DOCKETED	
Docket Number:	23-AFC-01
Project Title:	Morton Bay Geothermal Project (MBGP)
TN #:	256747
Document Title:	Morton Bay Geothermal LLC Responses to CURE Comments on the ICAPCD PDOC
Description:	N/A
Filer:	Lindsey Xayachack
Organization:	Jacobs
Submitter Role:	Applicant Consultant
Submission Date:	6/7/2024 1:12:18 PM
Docketed Date:	6/7/2024

RE: Selected Responses to the California Unions for Reliable Energy Comments on the Preliminary Decision to Grant a Preliminary Determination of Compliance for the Morton Bay Geothermal Power Generation Plant

Figure IV.A.1-1
Comparison of Wind Roses
Morton Bay Geothermal Project
Imperial County, California

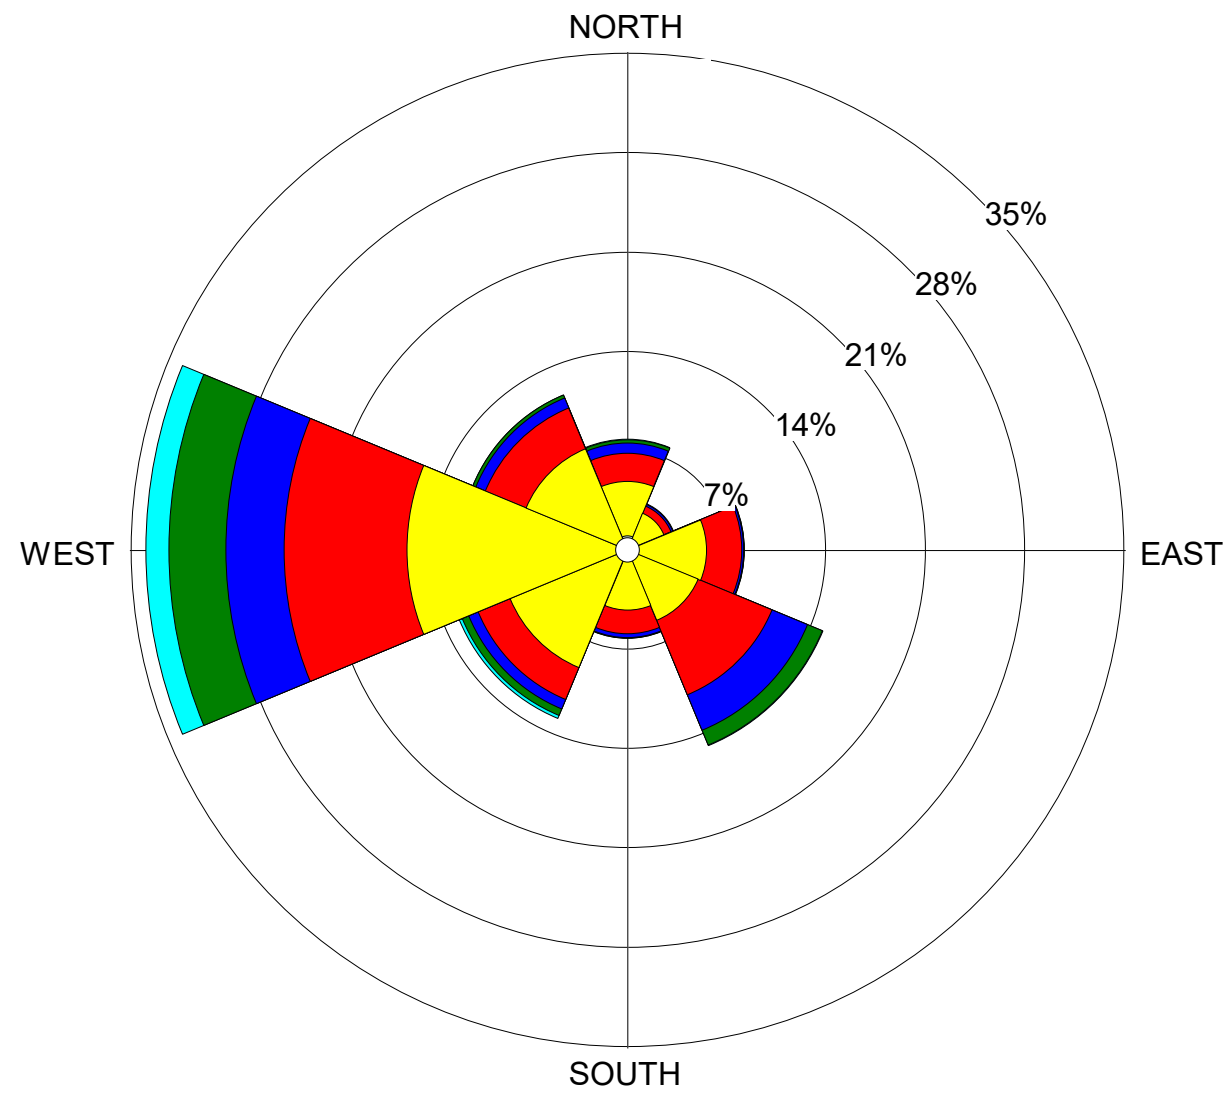
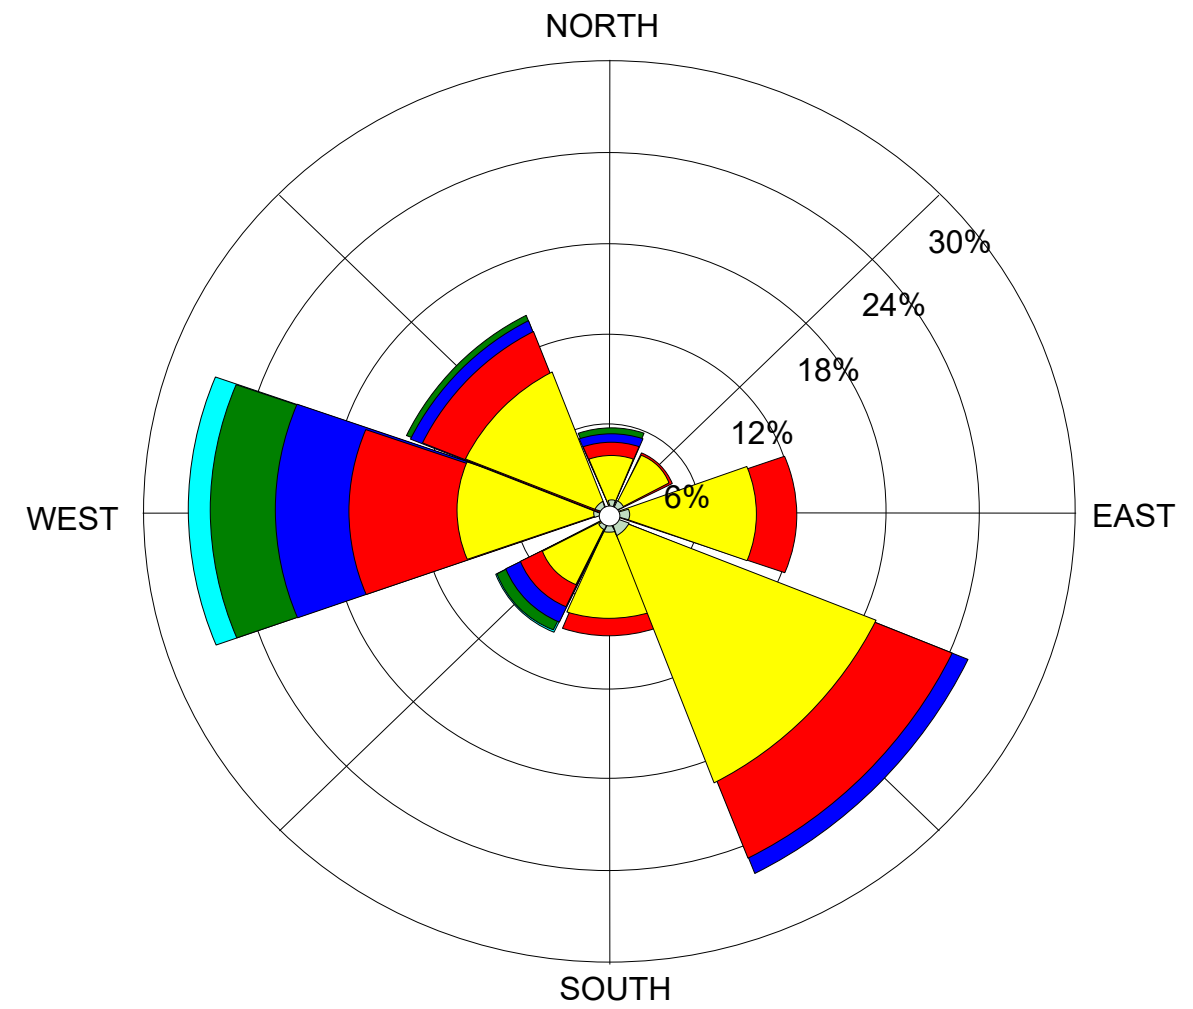
In Section IV, Subsection A.1 of its comments, CURE asserts that the air quality model relied upon by the Air District to determine the project's compliance with Ambient Air Quality Standards (AAQS) failed to utilize representative meteorological data.² This assertion is incorrect.

Lastly, although the Imperial County Airport is located over 28 miles from the project site, there are no significant geographic features between the two locations, and both are located south/southeast of the Salton Sea. The lack of significant geographic features between the two locations is itself an indicator of representativeness of the Imperial County Airport meteorological data,⁶ but also leads to the expectation that wind speeds and wind directions in the project vicinity are similar to those incurred at the Imperial County Airport. This expected similarity is verified by comparing the wind rose for the Imperial County Airport (for years 2015 to 2018 and 2021) to the wind rose for the Sonny Bono monitoring station (for years 2020 to 2022). As shown in Figure IV.A.1-1, attached hereto, both wind roses share the predominant wind directions from the west and southeast.

Based on the above, the meteorological data collected at the Sonny Bono monitoring station is not more suitable for modeling as the data does not meet the minimum requirements for completeness and would not be any more representative of the project site than the Imperial County Airport data based on a comparison of wind roses. Furthermore, as an ASOS station, the Imperial County Airport NWS station may provide fewer missing hours of wind speeds and wind directions. For these reasons, the Applicant supports the continued use of the Imperial County Airport NWS station meteorological data, as previously approved both by the ICAPCD and CEC.⁷

The Imperial County Airport is located approximately 28 miles from the project site. Significantly, for the purposes of the PDOC's conclusions, there are no significant geographic features between the two locations, and both are located south/southeast of the Salton Sea. The lack of significant geographic features between the two locations is itself an indicator of representativeness of the Imperial County Airport meteorological data,³⁵ but also leads to the expectation that wind speeds and wind directions in the project vicinity are similar to those incurred at the Imperial County Airport. This expected similarity is verified by comparing the wind rose for the Imperial County Airport (for years 2015 to 2018 and 2021) to the wind rose for the Sonny Bono monitoring station (for years 2020 to 2022). As shown in Figure IV.A.1-1, both wind roses share the predominant wind directions from the west and southeast.
